2015SYE157 – 396-402 Kingsway & 21-27 Flide Street,  
Caringbah

DA15/1401

## ASSESSMENT REPORT APPENDICES

Appendix	A	Draft Conditions of Consent
	B	Pre-Application Discussion dated 30 June 2015
	C	Architectural Review Advisory Panel Report dated 17 December 2015
	D	NSW Police Comments dated 9 February 2016
	E	Clause 4.6 Objection to Building Height

**Figure 1: Height non-compliance (Section D-D)**

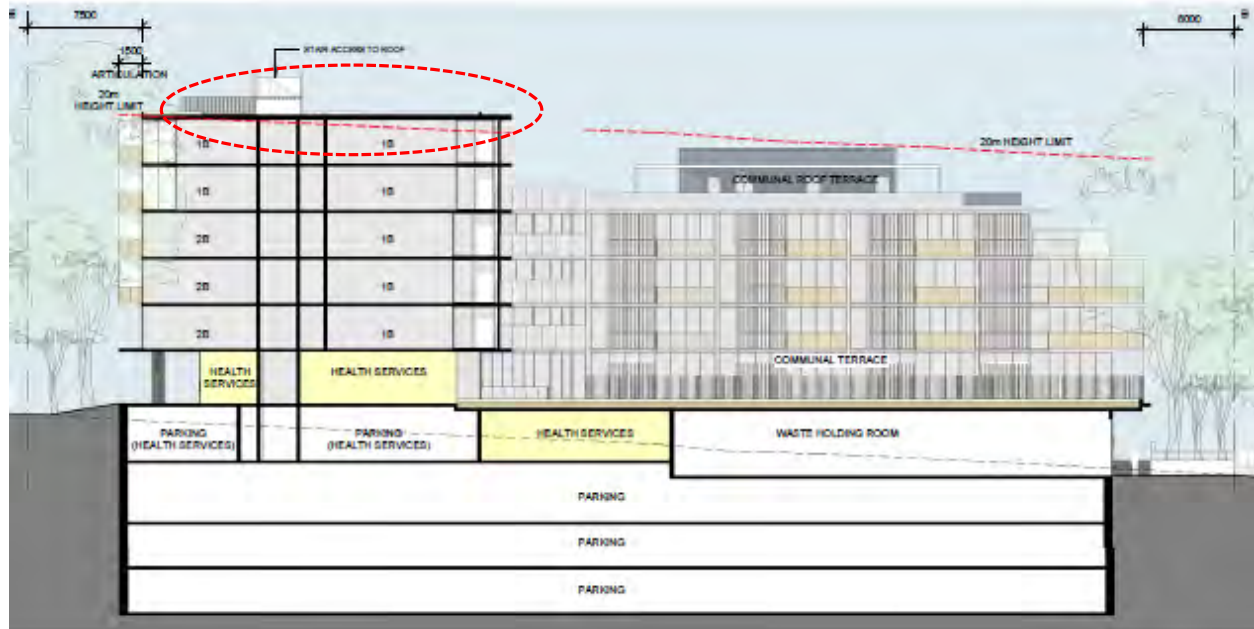
Figures 1 and 2 show the location of the extent of the building height non-compliance for Building A when the building is viewed in Section (D-D and E-E). It is noted that the height lines indicated in the elevation drawings are taken at the site boundary and therefore do not represent the extent of non-compliance. Non-compliances are best viewed in Section as indicated on plans DA203, DA204 and DA205.

The extent of non-compliance is circled red in Figures 1 and 2.
